AMENDMENT

ETS 300 324-1

**This amendment A1 modifies
the European Telecommunication Standard ETS 300 324-1 (1994)**

**Signalling Protocols and Switching (SPS);
V interfaces at the digital Local Exchange (LE);
V5.1 interface for the support of Access Network (AN);
Part 1: V5.1 interface specification**

Page 188, figure L.9.1, state "OUT OF SERVICE"

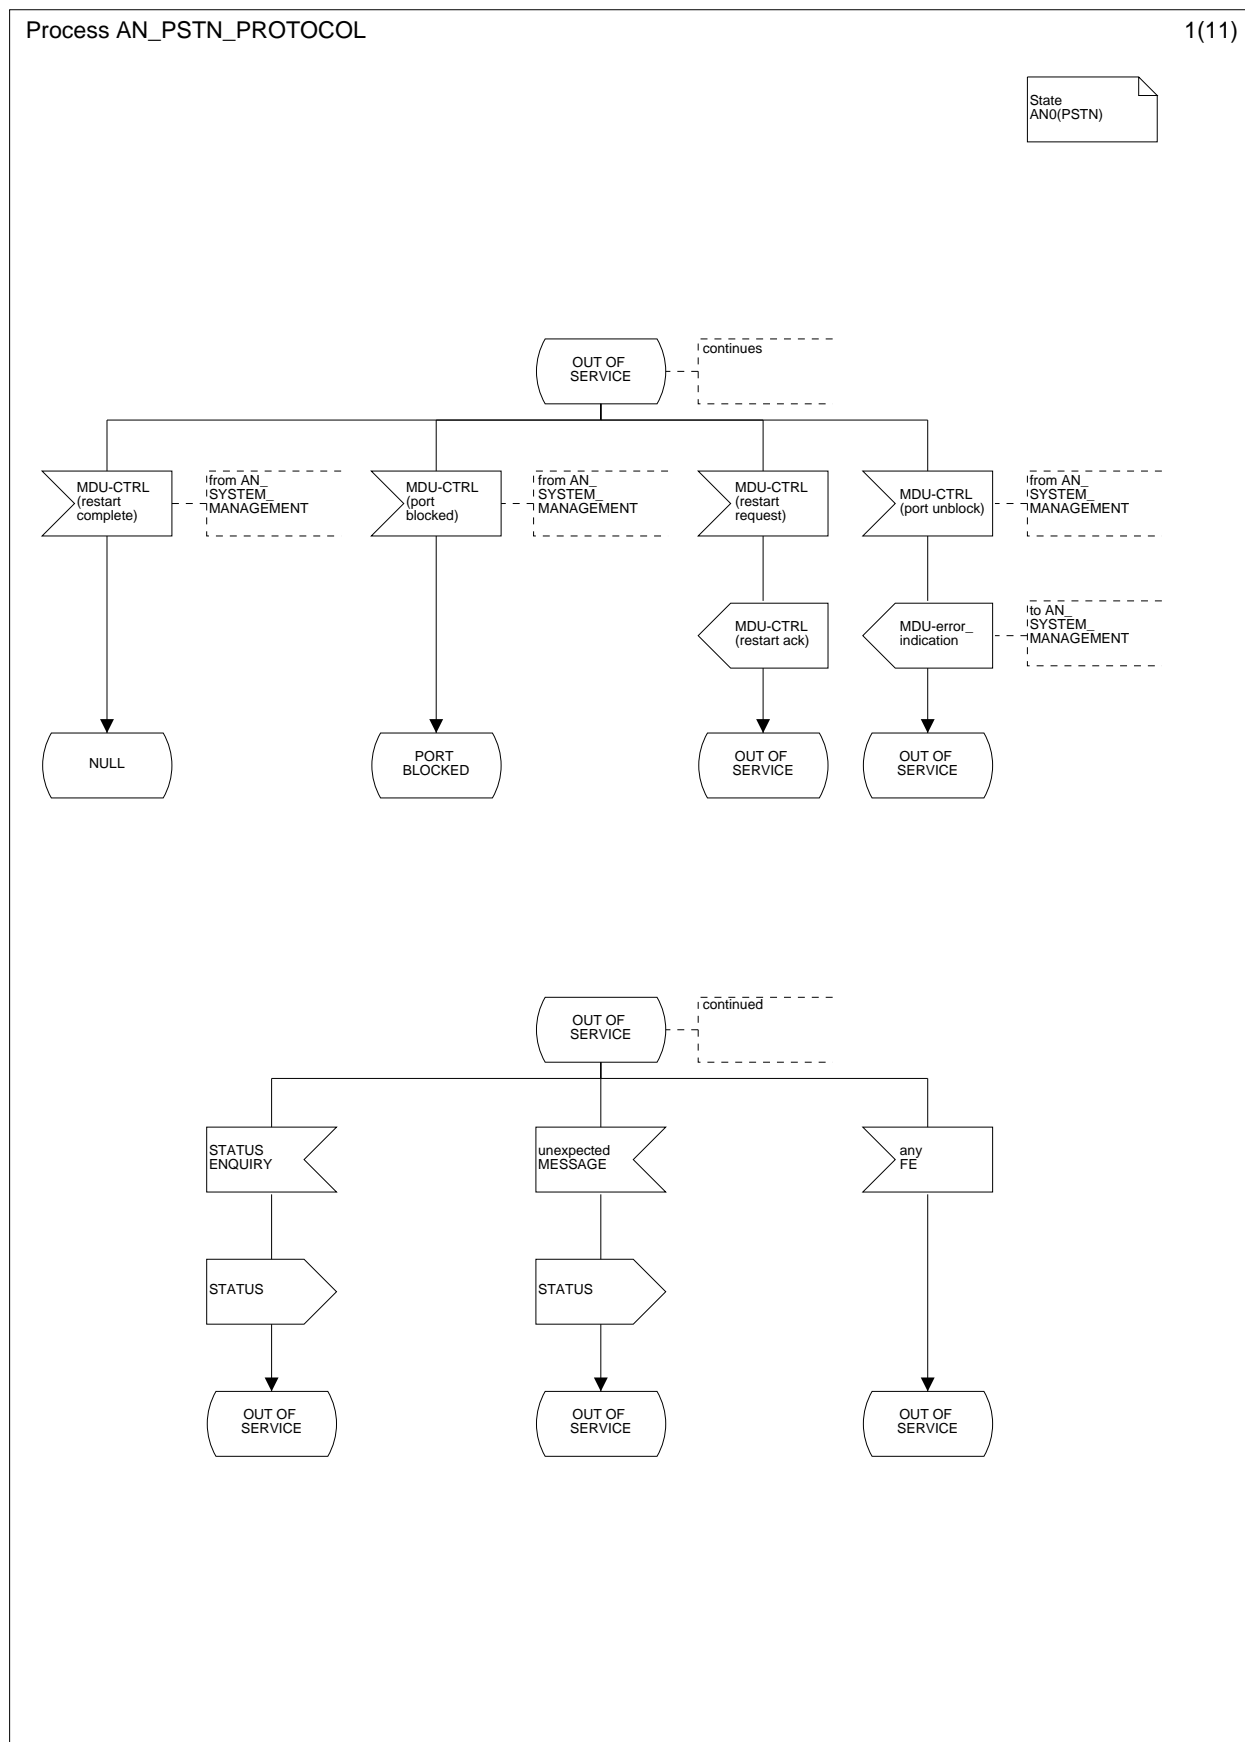
Delete the start symbol.

Page 192, figure L.9.5, state "LINE INFORMATION", branch "other MESSAGE"

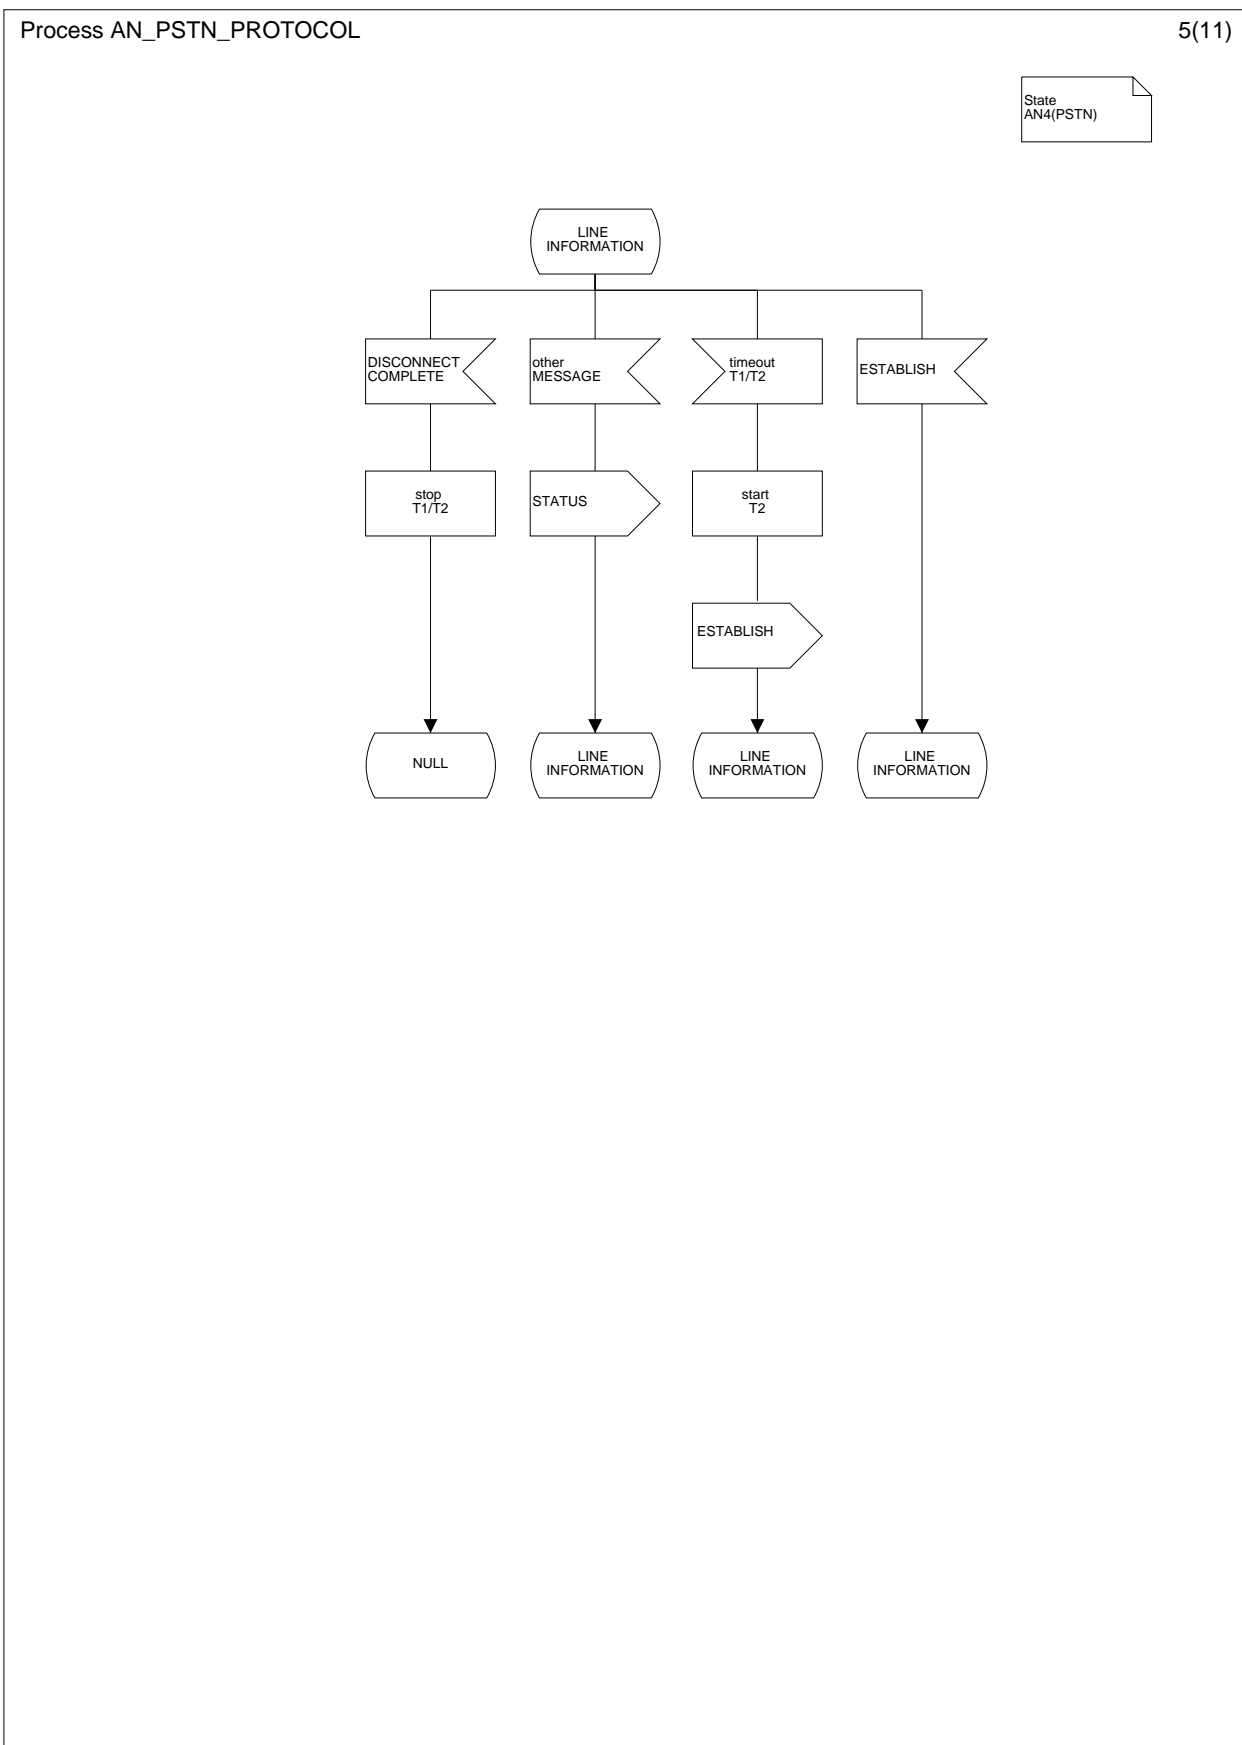
- Annex C, table C.1: "Cause for start" of Timer TC2 is wrong.
Amendment: The cause for start is corrected.
- Annex L, figure L.9.5: Figure L.9.5 is contradictory to table 29 concerning the handling of an ESTABLISH message in state AN4. Table 29 requires "No action, no state change", figure L.9.5 requires the sending of a STATUS message.
Amendment: Update of figure L.9.5 according to table 29.

Add a new branch "ESTABLISH" as shown below.

Page 196, figure L.9.9, state "PORT BLOCKED"

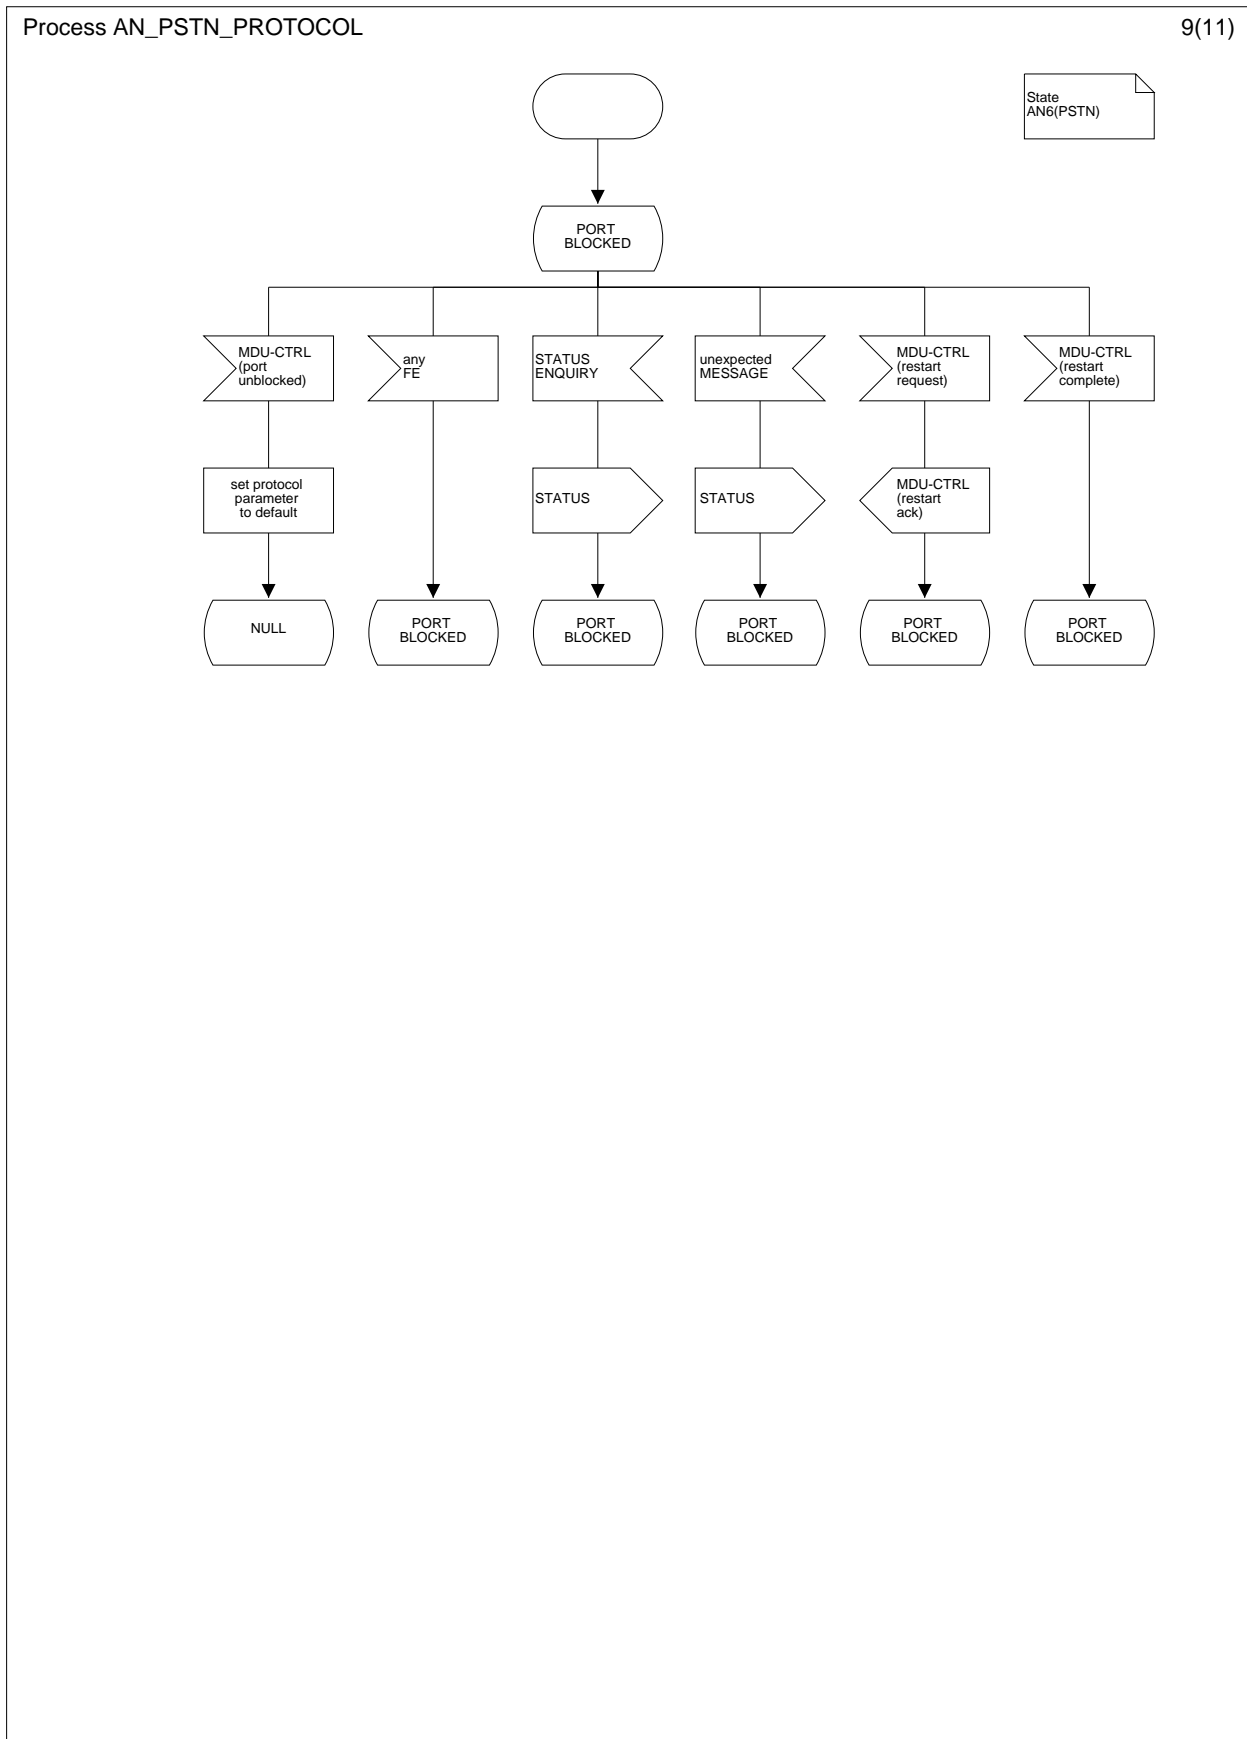
Add the start symbol and a transition to "PORT BLOCKED".

Page 197, figure L.9.10, state "DISCONNECT REQUEST", branch "PROTOCOL PARAMETER"

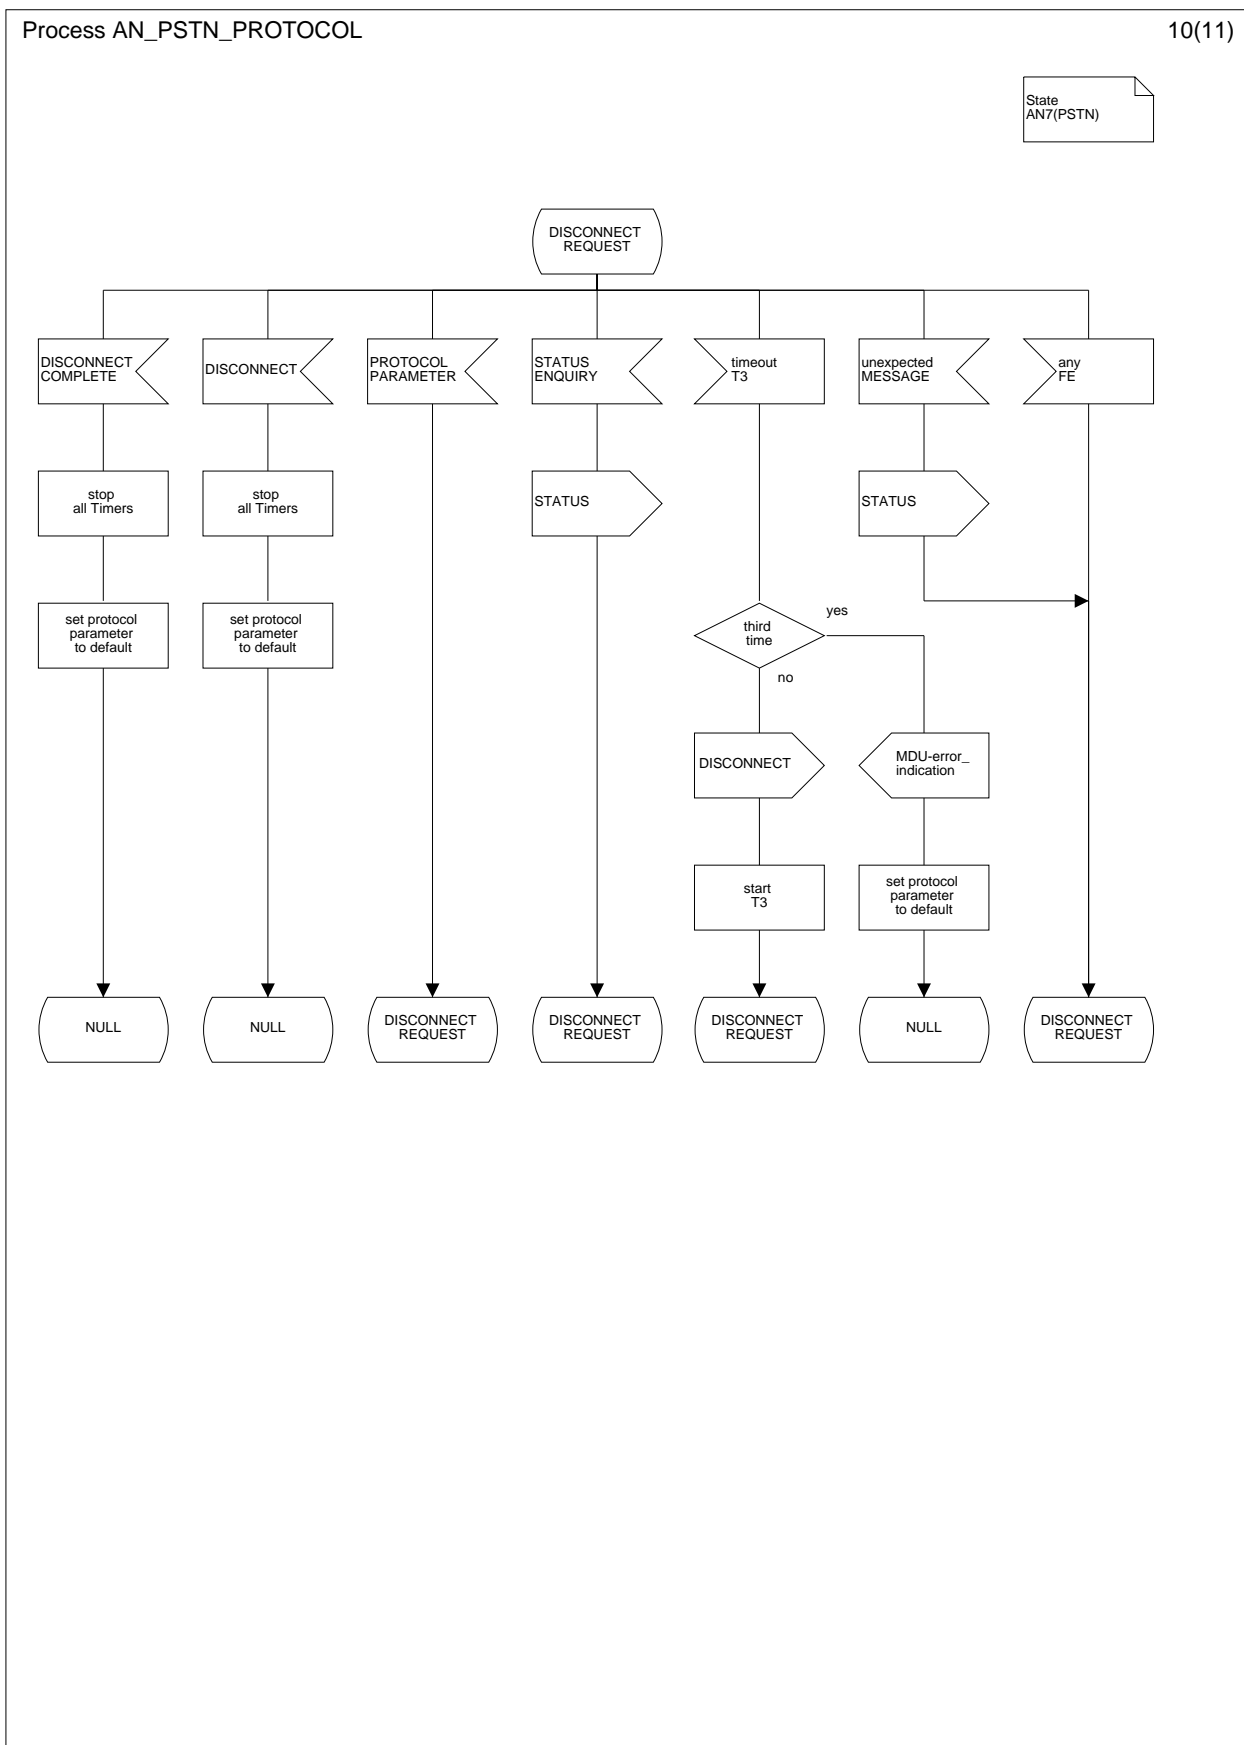
Amendment: Table 29, state AN7, event PROTOCOL PARAMETER: No STATUS has to be sent. The text in subclause 13.5.4.1.2 and the SDL diagram in figure L.9.10 are adapted accordingly.

Delete the sending of STATUS message.

Page 217, figure L.17.1, state "SYSTEM STARTUP"

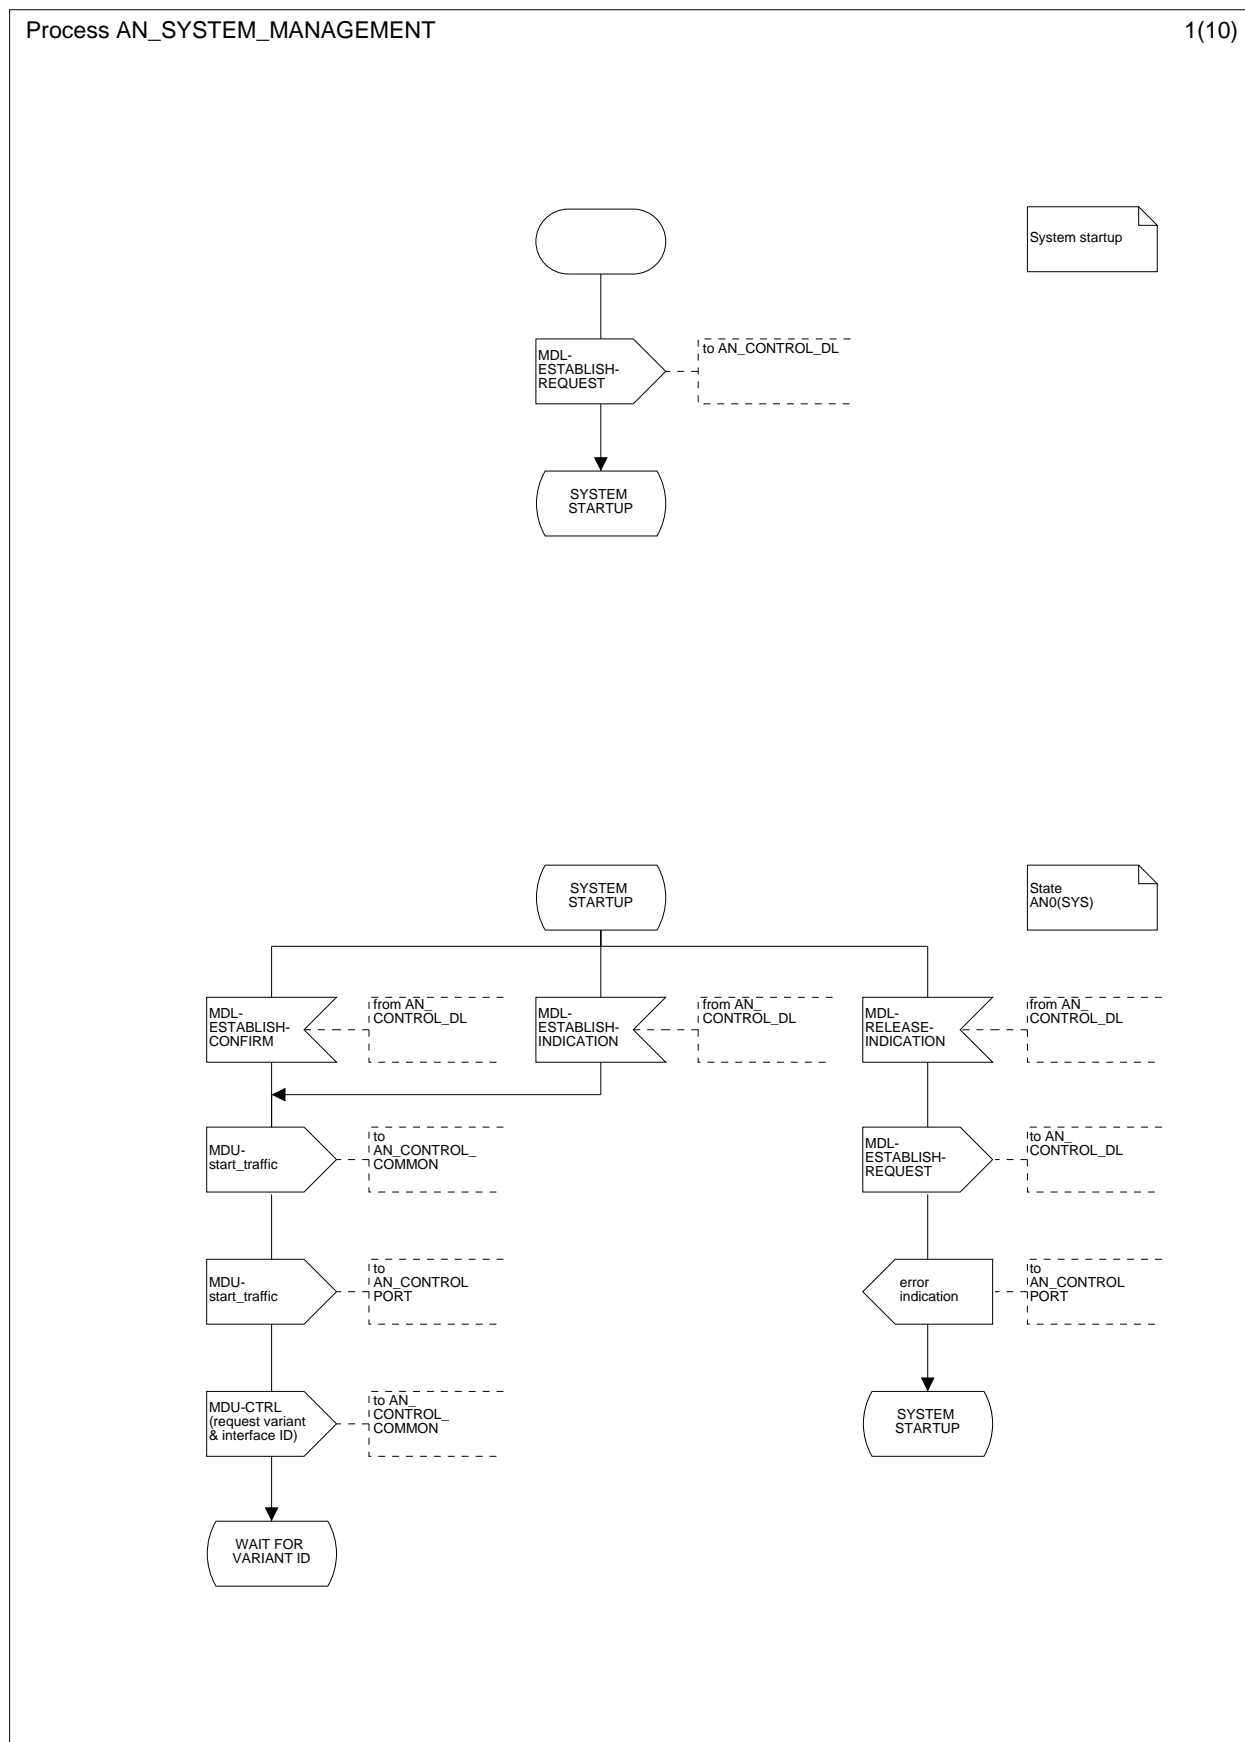
- Annex L, figure L.17.1: If during startup the CONTROL_DL is not able to establish the connection (sending of SABME four times), it sends MDL-RELEASE-INDICATION to system management. In figure L17.1, this event is not shown and the required reaction of system management is not clear.
Amendment: Update of figure L.17.1 to show the sending of MDL-RELEASE-INDICATION.

Add a new branch "MDL-RELEASE-INDICATION" as shown below.
